April 2005

SUBJECT: SAFETY RECALL (U.S., EXPORT)
**TURN SIGNAL SWITCH assemblies on certain 3300,
4200, 4300, 4400, and CE School Bus models built
5/24/2004 thru 8/17/2004**

Figure 4

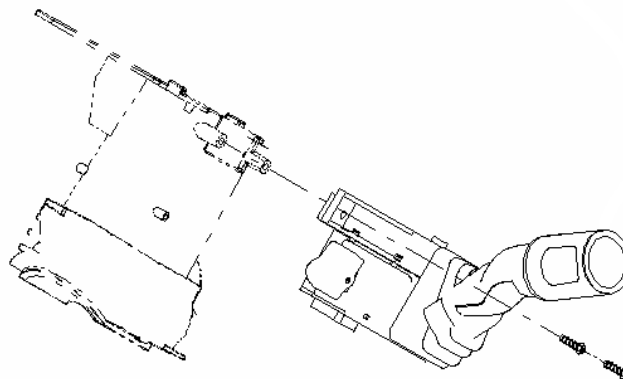
7. Install new switch assembly and connect electrical connector. See **Figure 4**.
 - a. If the vehicle has a Blue Bird body, use **2589451C91**.
 - b. For all other vehicles and bus bodies, use **3587009C91**.
8. Perform functional test on switch to verify all turn signals and hazard lamps function.
9. Re-install upper and lower steering column trim panels. See **Figure 1**.
